11 SEP 1979  
LONG BOTTOM BRANCH DAM

BUCHANAN COUNTY, VIRGINIA

# PHASE I INSPECTION REPORT

## 6 NATIONAL DAM SAFETY PROGRAM

PLATE NO. 2

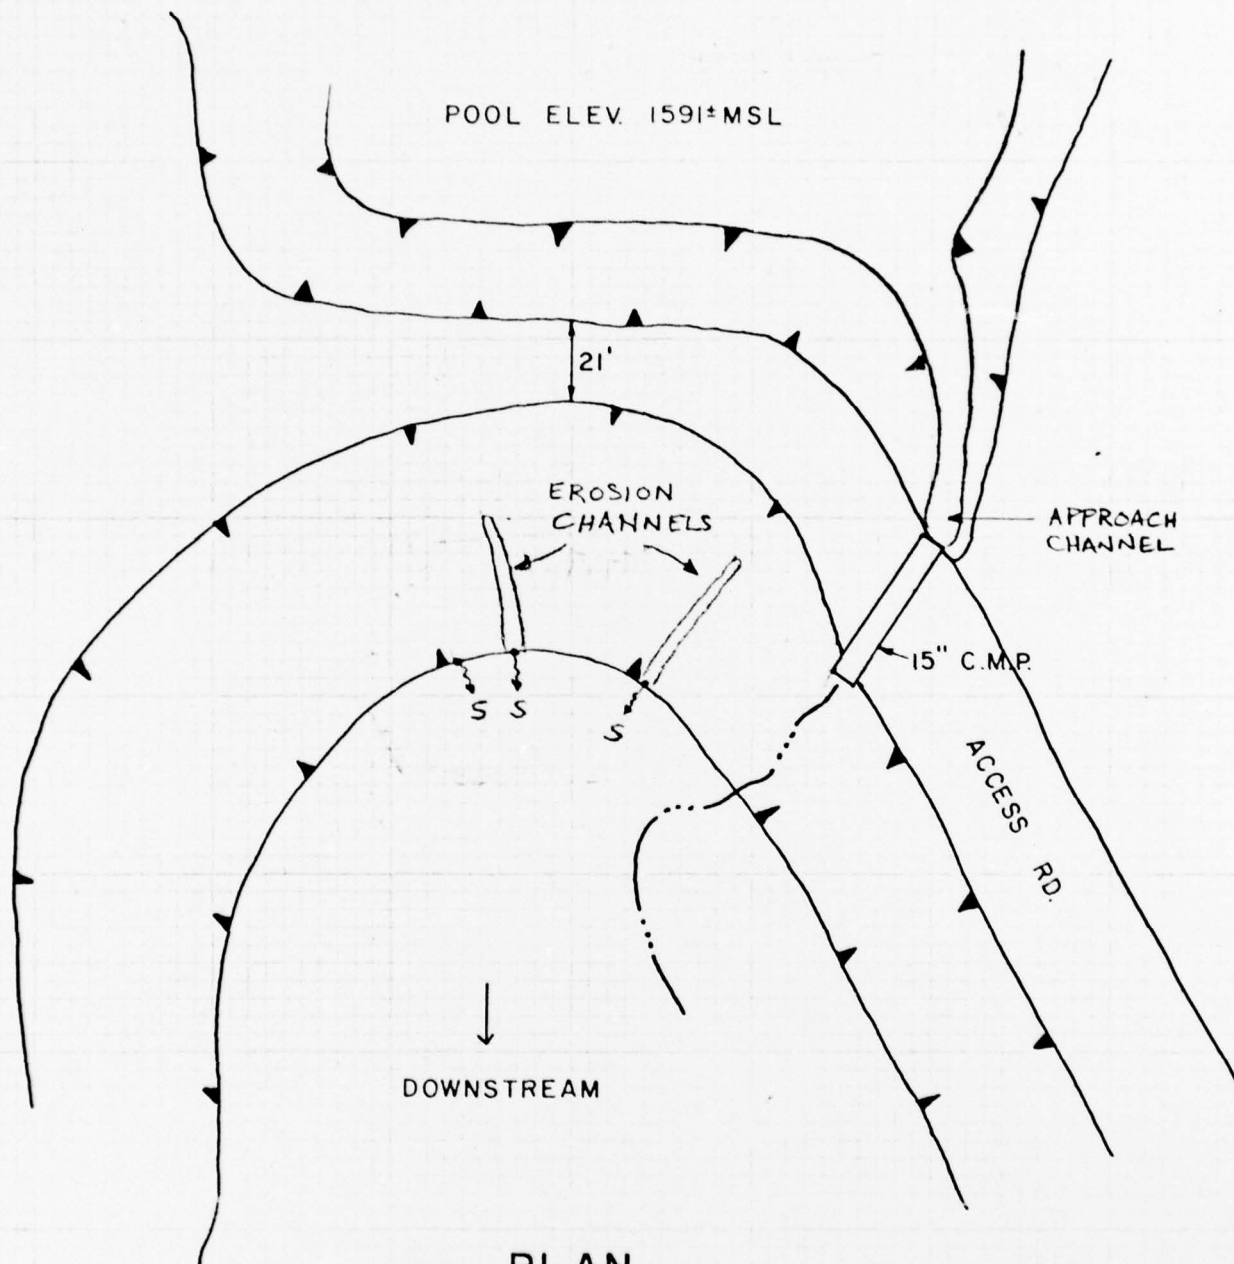
encountered on the downstream slope along the left abutment and to the right of the dam center where the dam curves into the right abutment. These eroded areas were up to 3 ft wide, 1 to 2 ft deep, and extended from about halfway down the slope to the toe. Three seeps, each flowing at 2 gpm<sup>±</sup> were encountered. Two occur along the toe of the eroded channels or washes and the third was approximately 10 ft right of the right erosion channel along the toe of the slope. Heavy iron staining was associated with the three seeps. Erosion and seepage features are illustrated on Plate 2, Appendix I.

1.3 Sloughing or Erosion: Two erosion channels or washes were observed on the downstream slope along the left abutment and along the right edge of slope where the dam curves. The eroded areas were up to 3 ft wide and 1 to 2 ft deep. They extend from about half way down the slope to the toe. Erosion also exists at the spillway outlet.

1.7 Seepage: Three seeps were encountered during the inspection. Two were located along the toe of the two eroded channels or washes and the third was approximately 20 ft right of the right erosion channel along the toe of slope. Seepage from all three areas was estimated as 2 gpm<sup>±</sup>. Heavy iron staining was generally present along seepage paths.

7.3.1 Seepage observed along the downstream toe of the embankment should be monitored quarterly to detect any increase in flow rates which may cause piping within the embankment.

7.3.3 All trees on the embankment should be removed and excavations backfilled with compacted fill. Eroded areas should also be backfilled and the embankment reseeded. Surface drainage should be diverted to prevent future erosion.
